**BASELINE MONITORING
DOCUMENT AND AS-BUILT
BASELINE REPORT
FINAL**

DRY CREEK MITIGATION SITE

DMS Project Number 97082

Subject: DMS Comments on the Draft Baseline Report and Record Drawings Review
Dry Creek, Project ID #97082, DMS Contract #0006827

Dry Creek Mitigation Site
Durham County, NC
Planting Plan

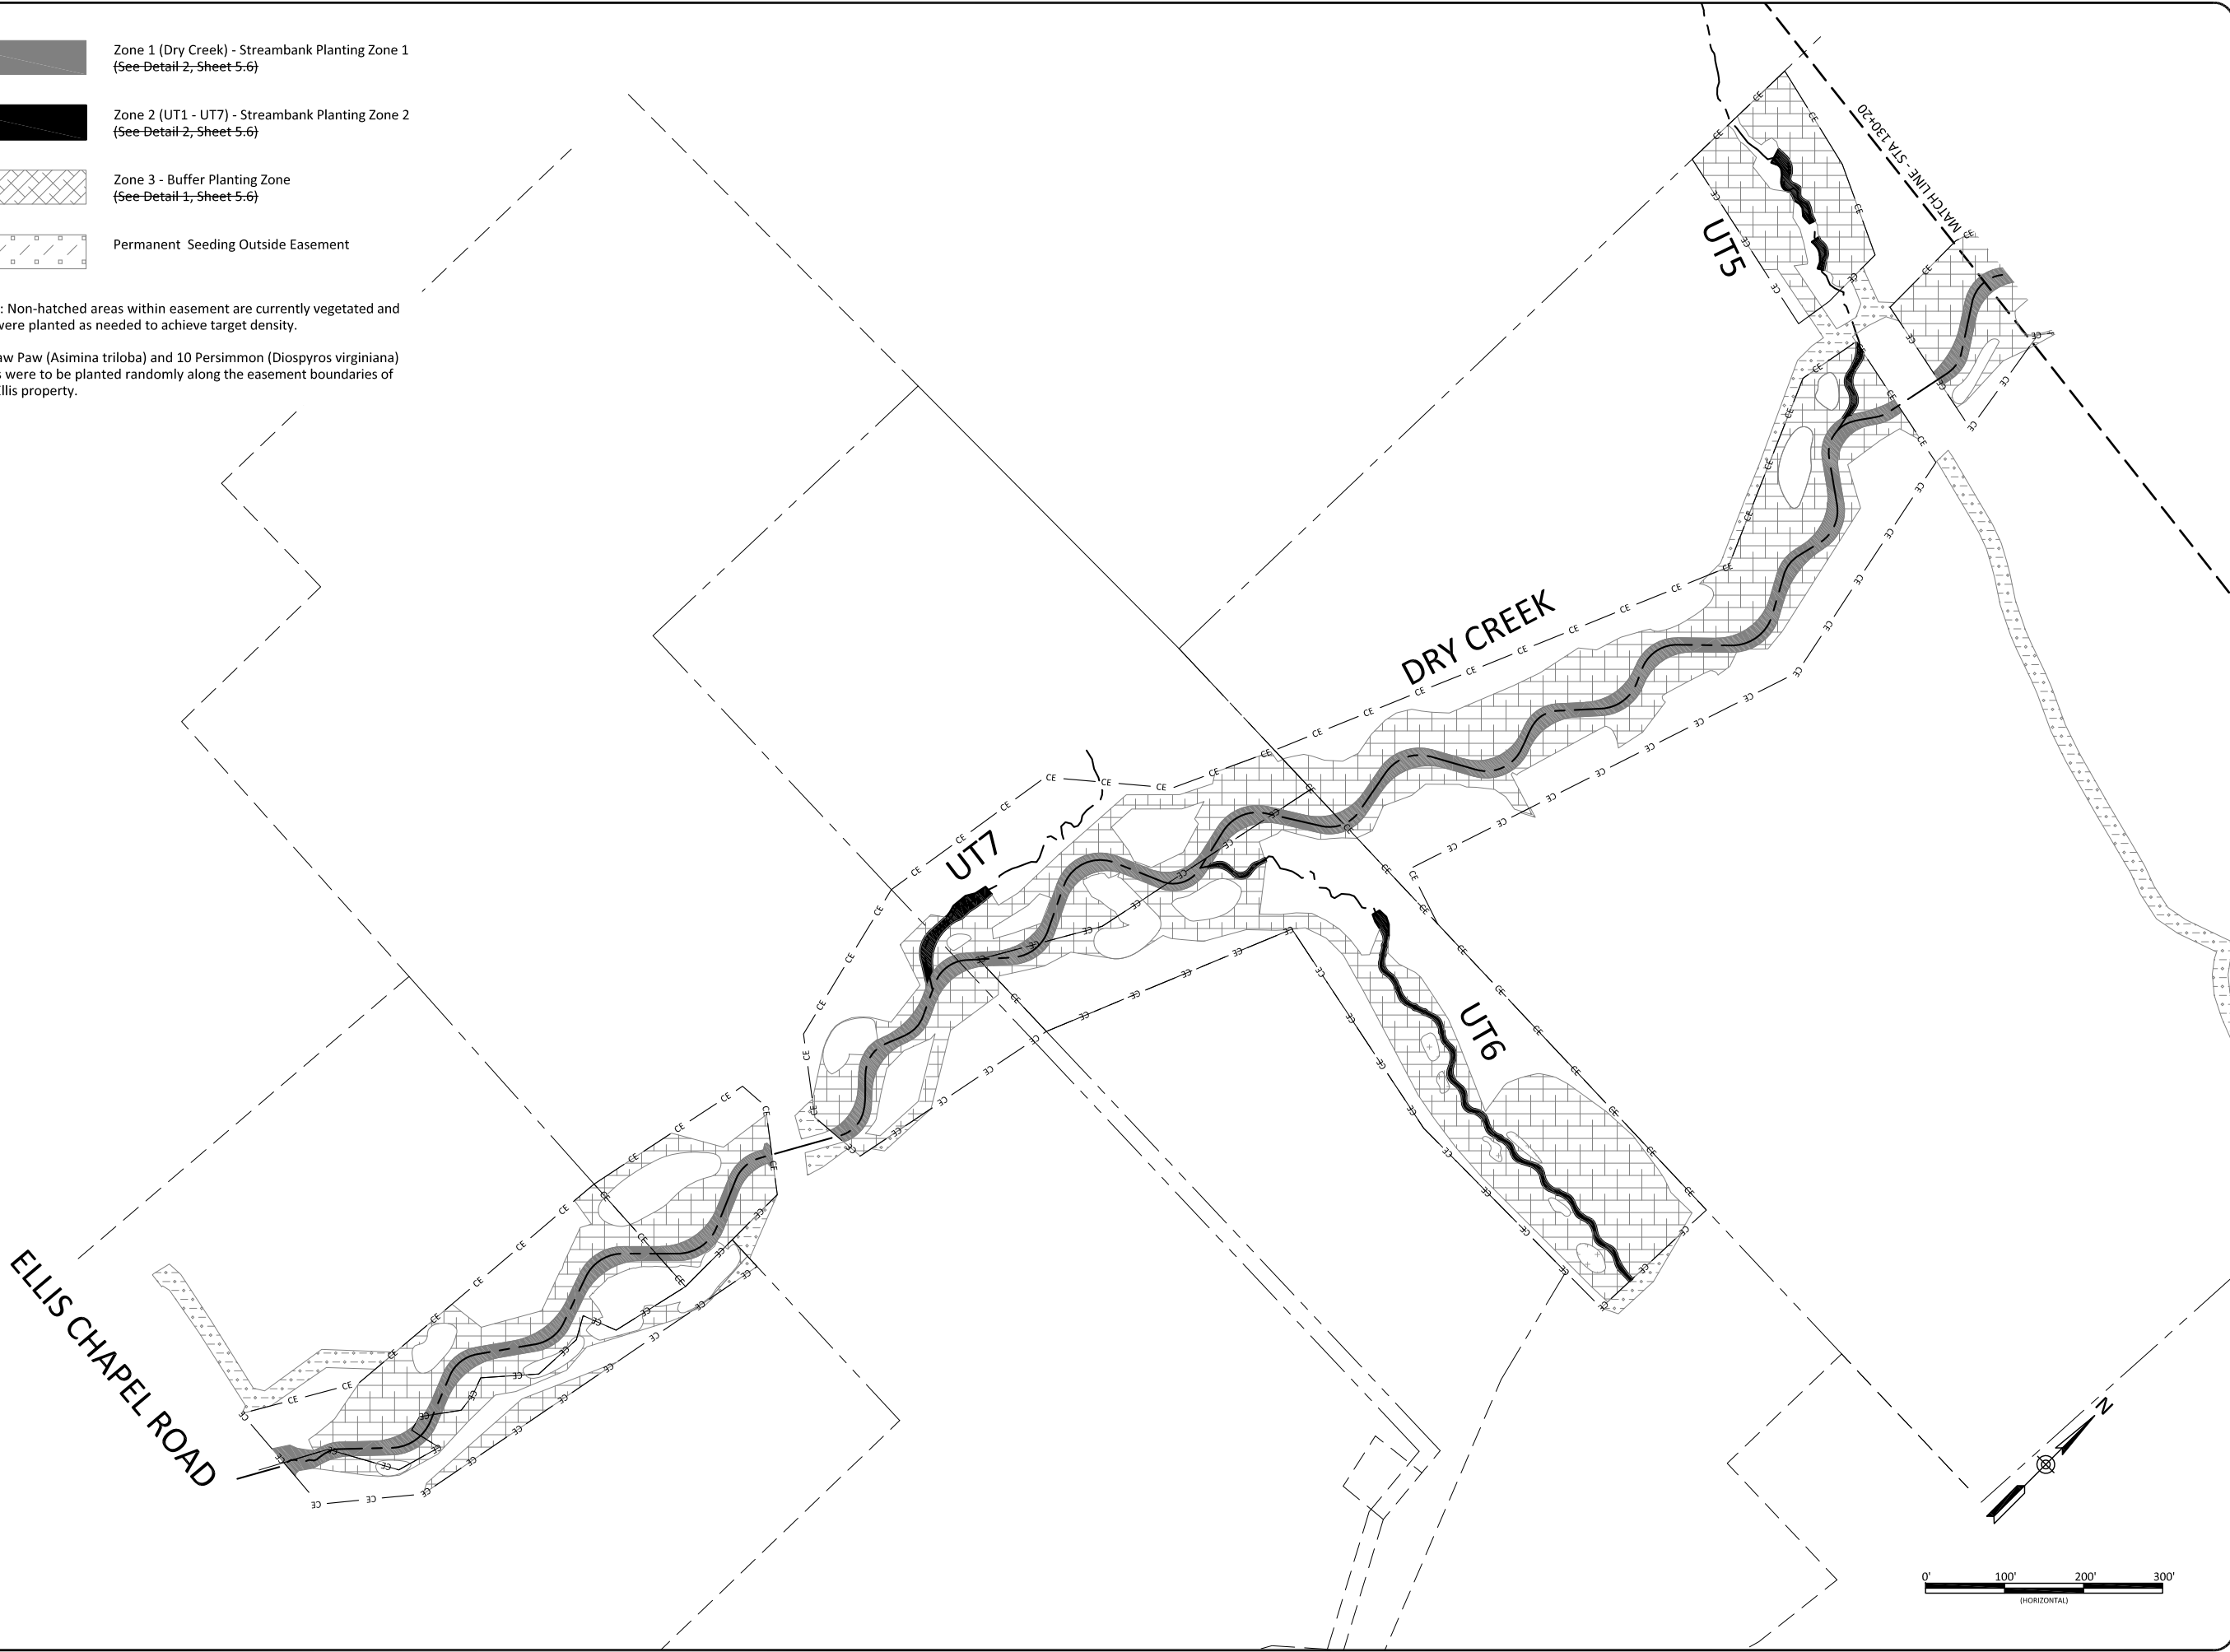
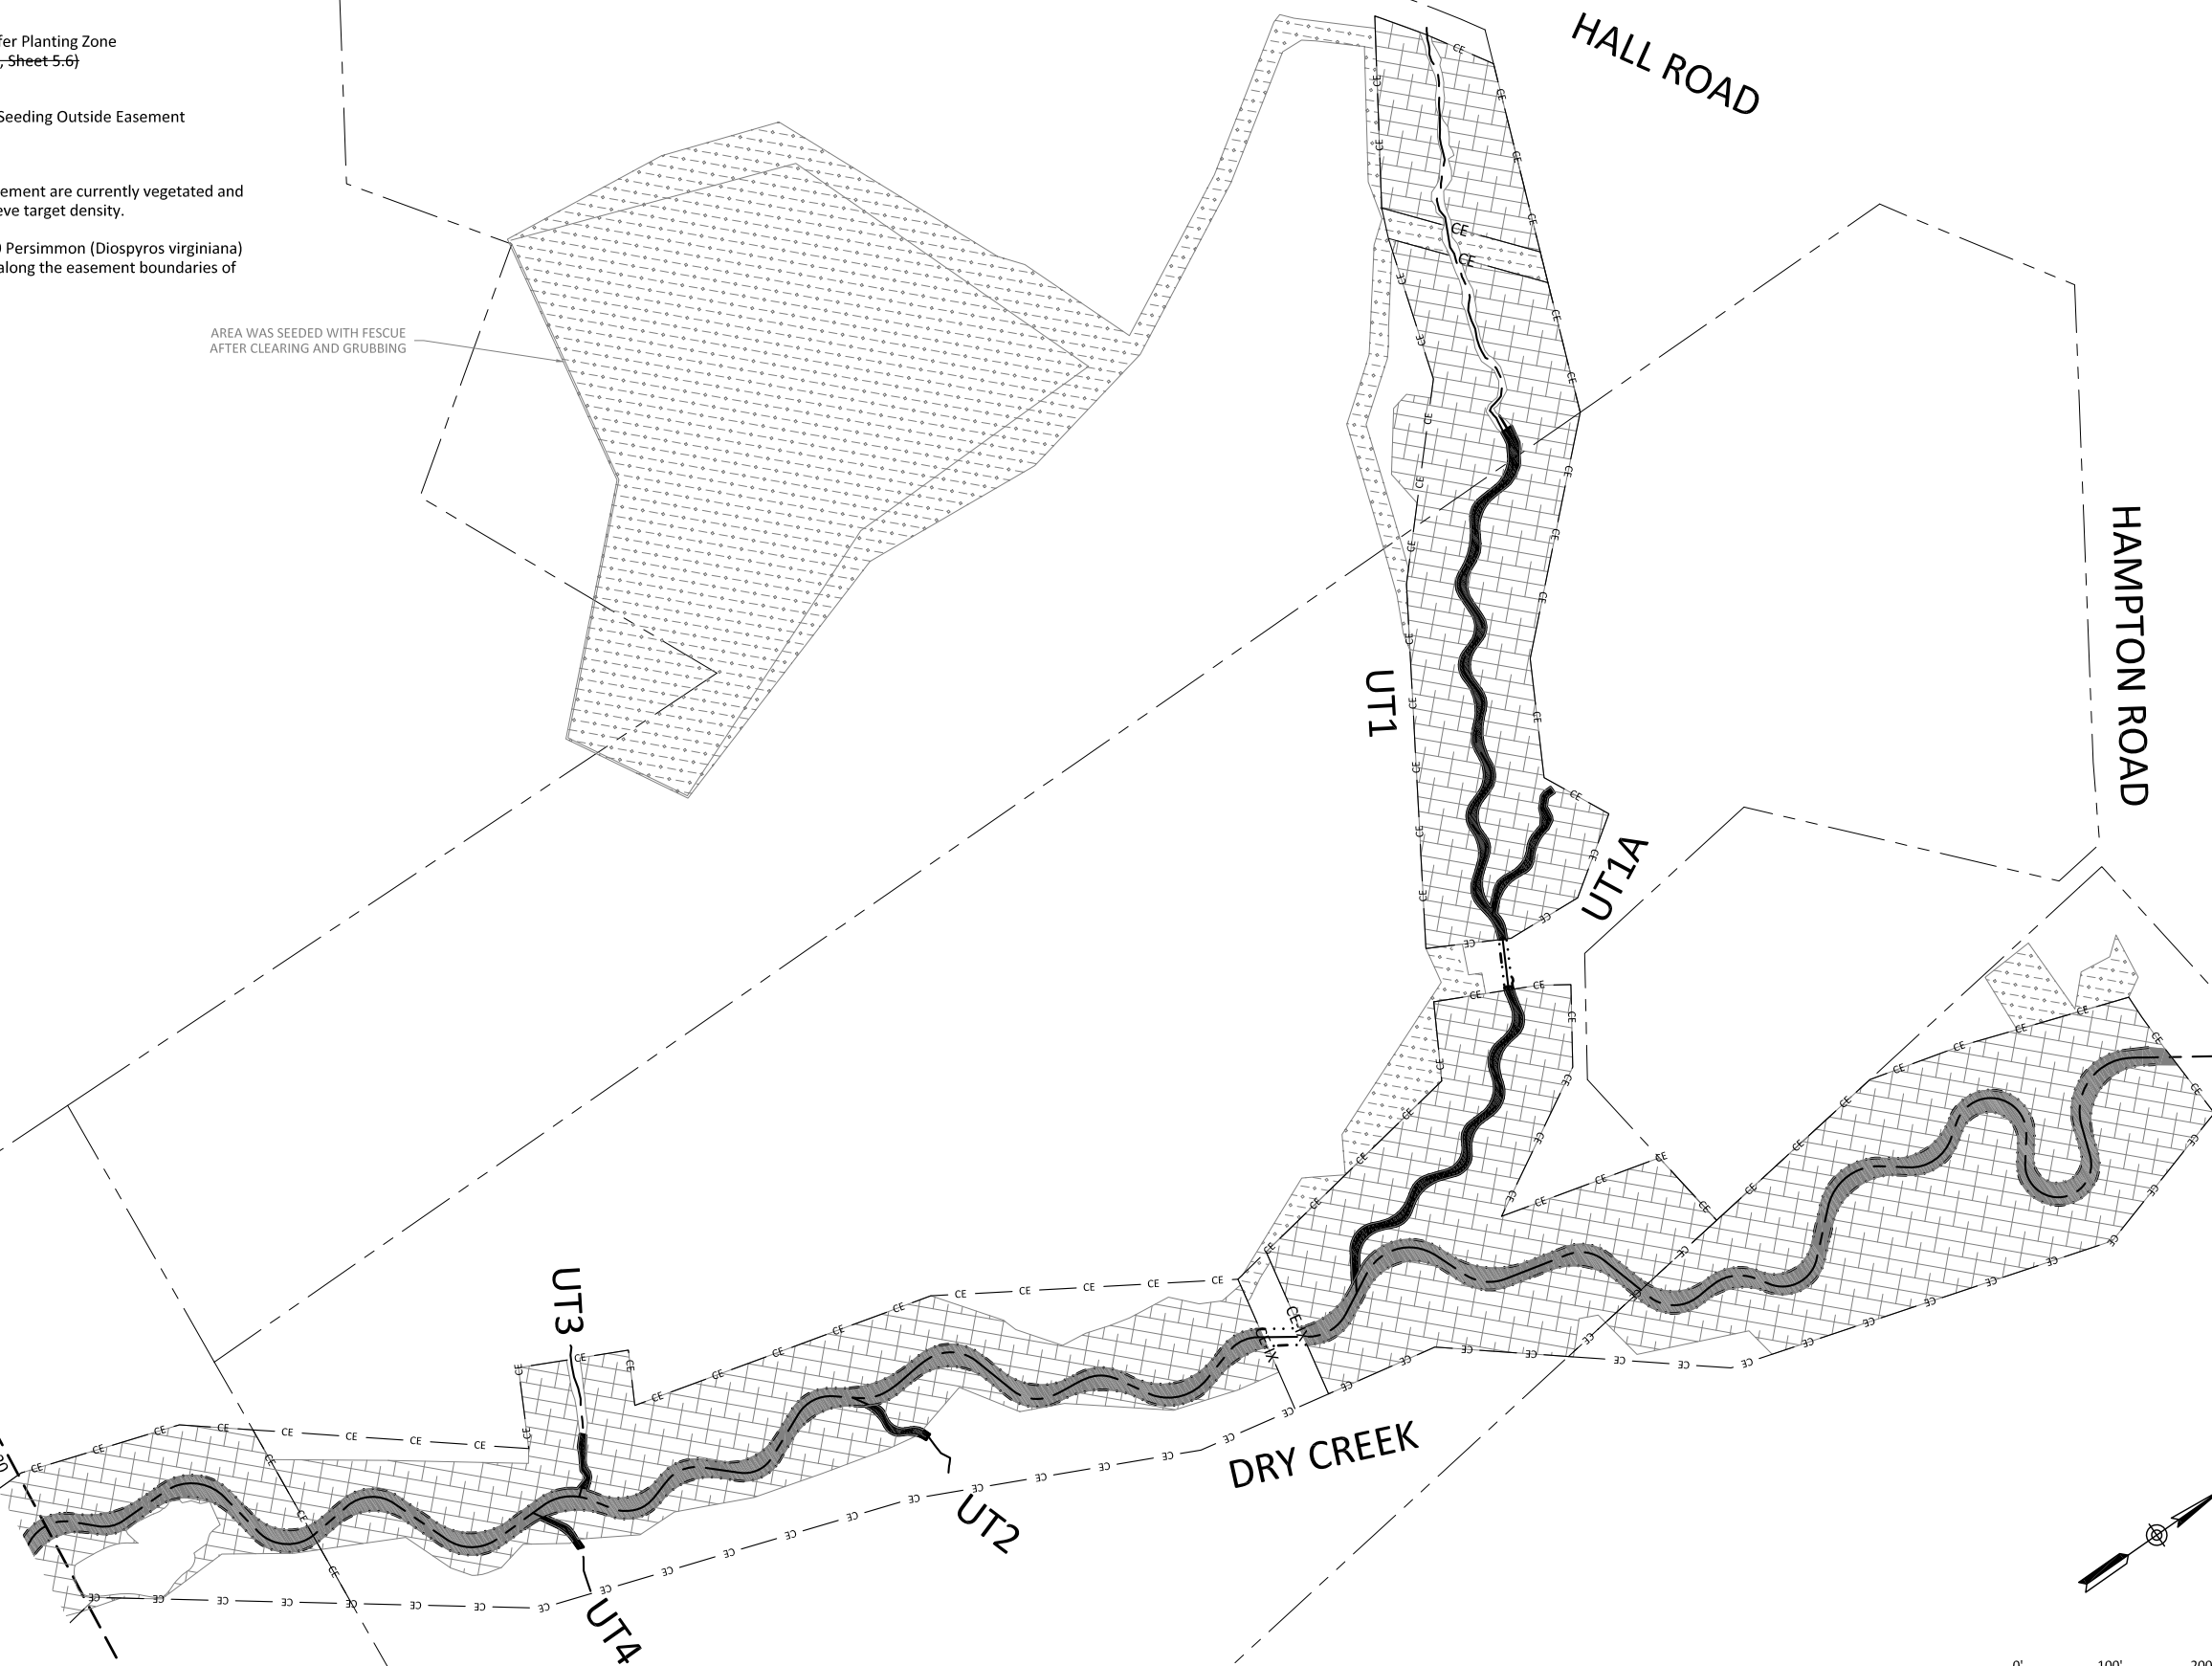
5. As-Built drawings sheet 2. There were some notes that sod was not available, indicating that plugs may not have been installed per vegetation planting specs shown on this page. Verify that there were no changes to the percentages, shrubs, trees, other species shown on this page. Suggest adding table to show the number and species of planted trees with total plants (these were listed in the Riparian Buffer Appendix but not stream and wetland portion).

Wildlands confirmed that there were no deviations from the vegetation planting specs, and the number of each tree species planted was added to the planting table.
